Forest
Service

Manti-LaSal
National Forest

APPROVED CHANGES TO THE FOREST PLAN

DI-1

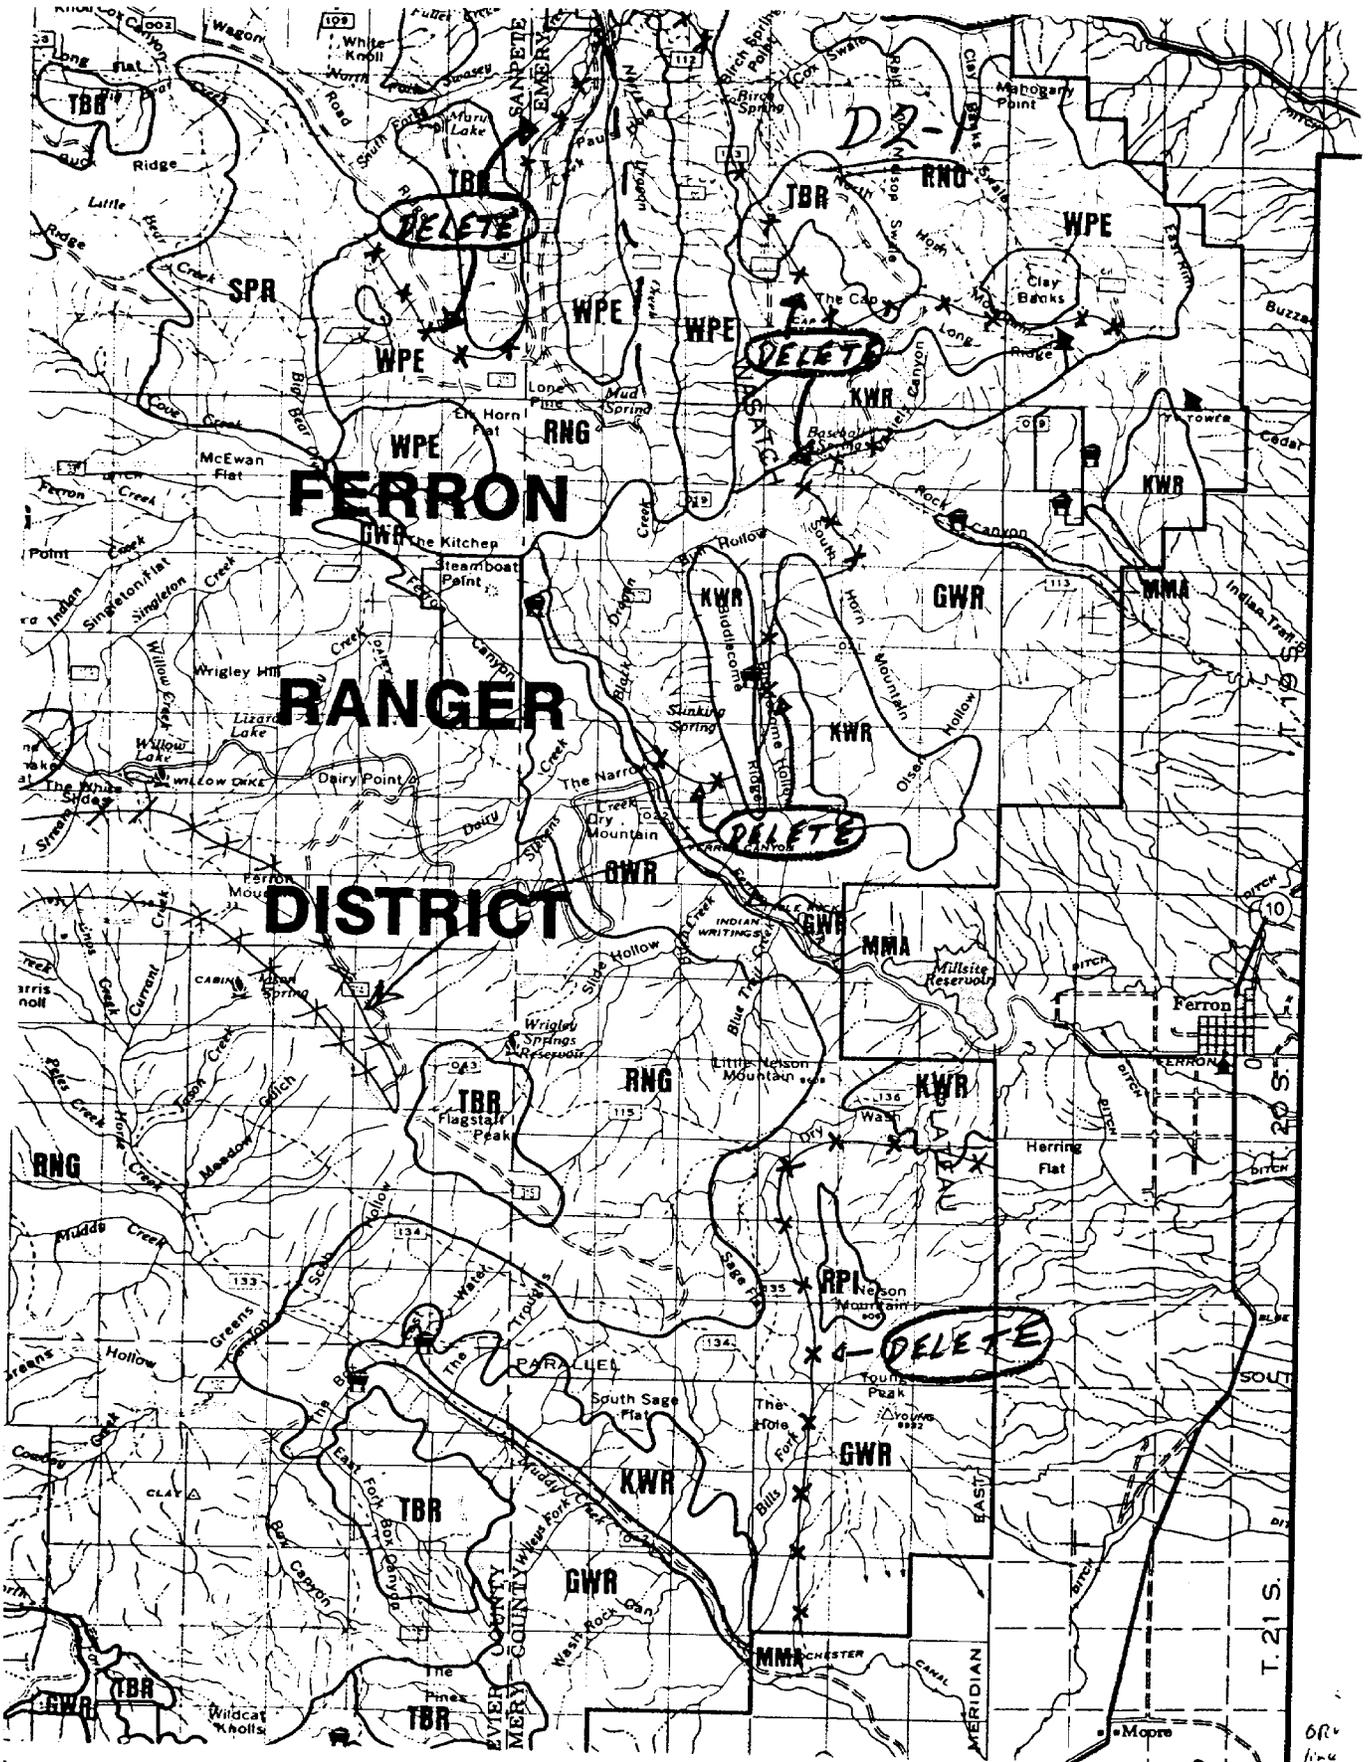
- D1-1 - CORRECT MAP ERROR. CHANGE FOREST PLAN MAP TO SHOW CORRECT MANAGEMENT UNIT EMPHASIS IN MANTI CANYON. AREA SHOWN AS GWR SHOULD BE TBR. (SEE PLAT A)

D2-5

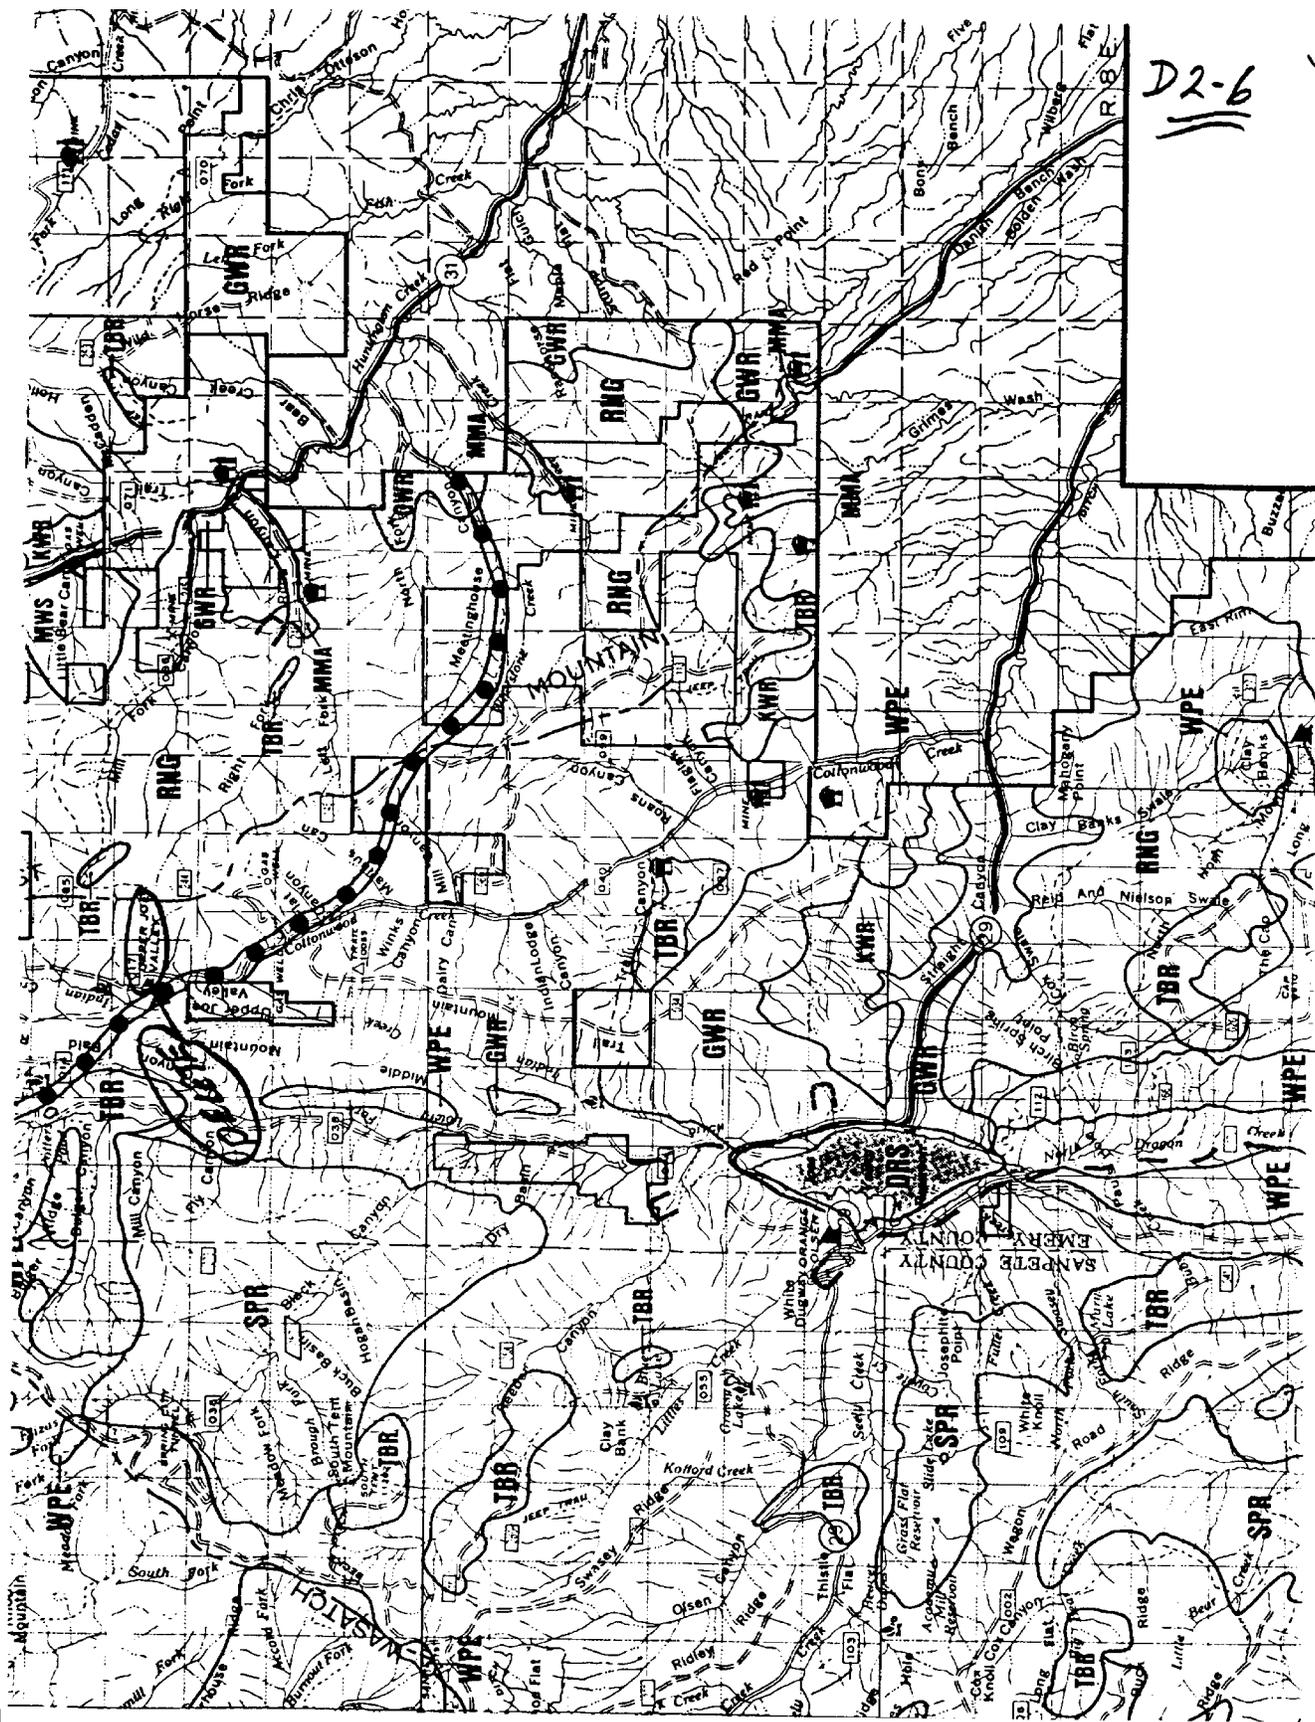
- D2-4 - CORRECT MAP ERROR. CHANGE THE IDENTIFICATION OF SITES ON NORTH HORN MOUNTAIN FROM ADMINISTRATIVE TO ELECTRONIC SITES. (SEE PLAT D)
- D2-5 - CORRECT MAP ERROR. IDENTIFY THE AREA IN COTTONWOOD CANYON AS MMA MGMT. UNIT. (SEE PLAT E)

D2-6

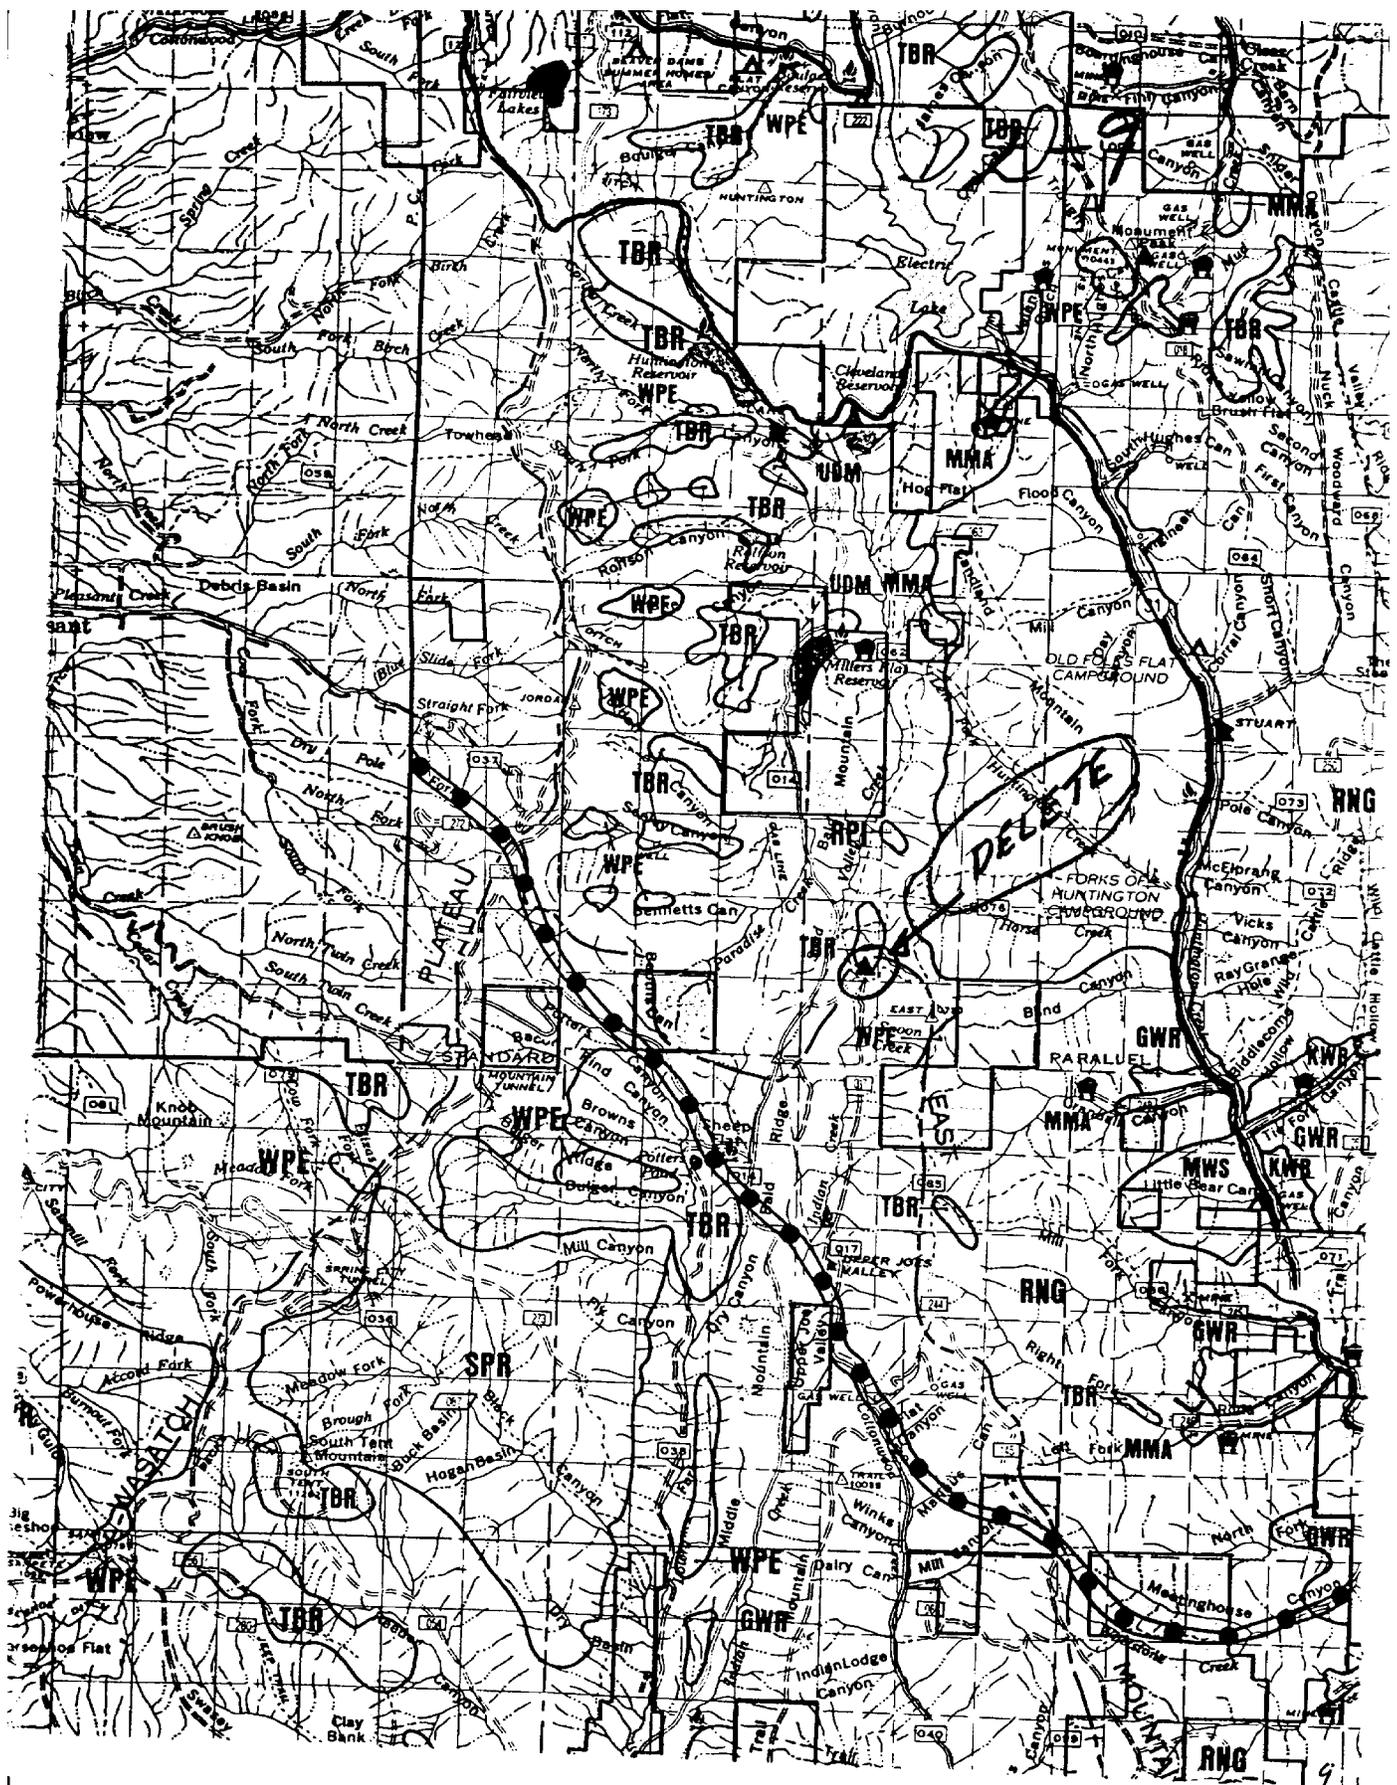
- D2-6 - CORRECT MAP ERROR. DELETE INDIAN CREEK GUARD STATION. (SEE PLAT F)
- D2-7 - CORRECT MAP ERROR. CHANGE A UDM SITE TO A DRS SITE. (SEE PLAT G)
- D2-9 - CORRECT MAP ERROR. DELETE ELECTRONIC SITE AT MIDDLE MOUNTAIN. (SEE PLAT H)

D2-10

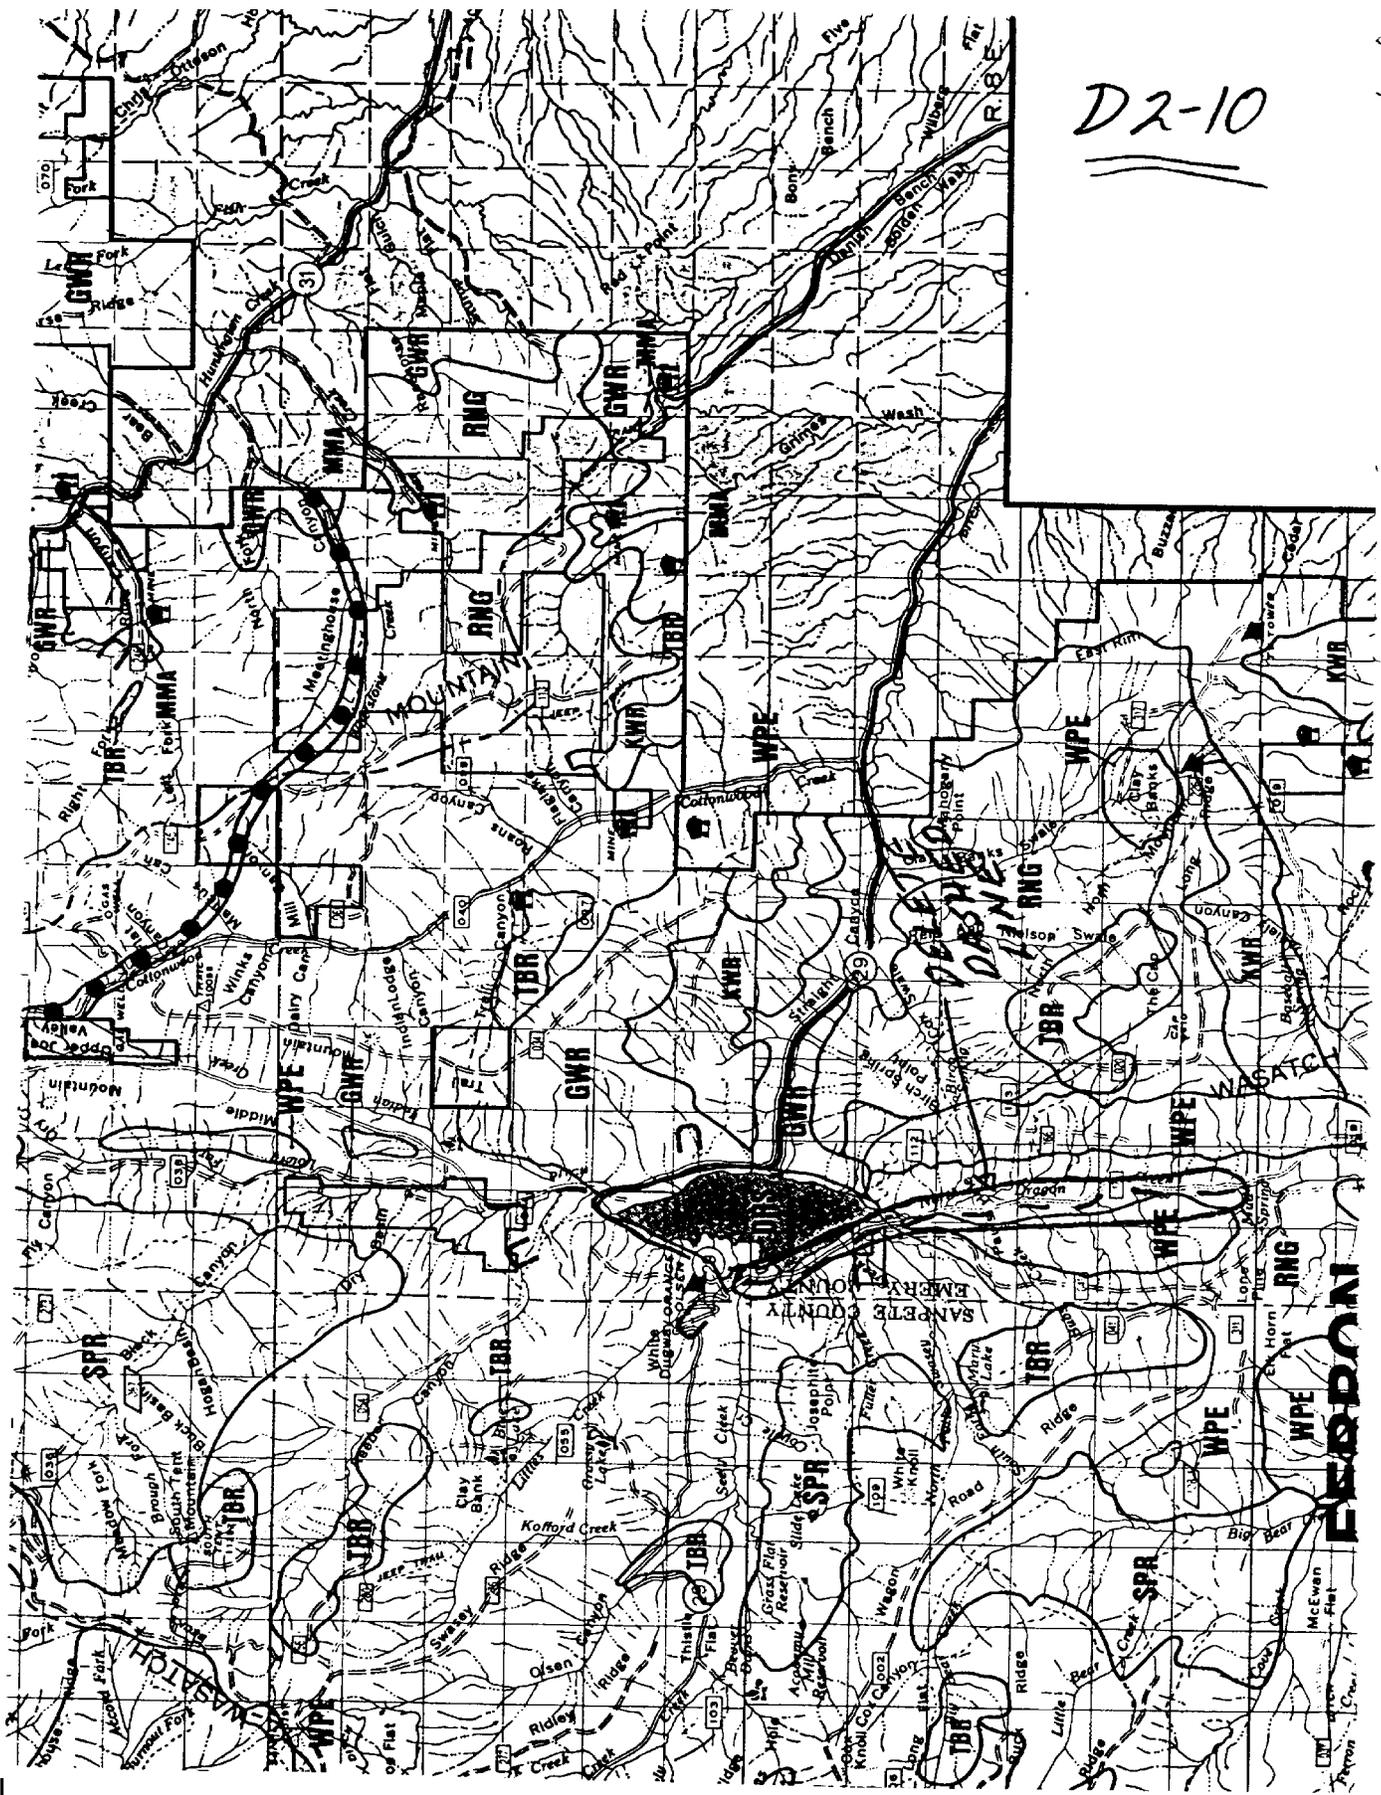
- D2-10 - CORRECT MAP ERROR. REMOVE THE DASHED LINE IN JOES VALLEY ON THE FOREST PLAN MAP. (SEE PLAT I)
- D2-12 - CORRECT MAP ERROR. DELETE PLANNED TRAILER SITE GUARD STATIONS. (SEE PLAT J)
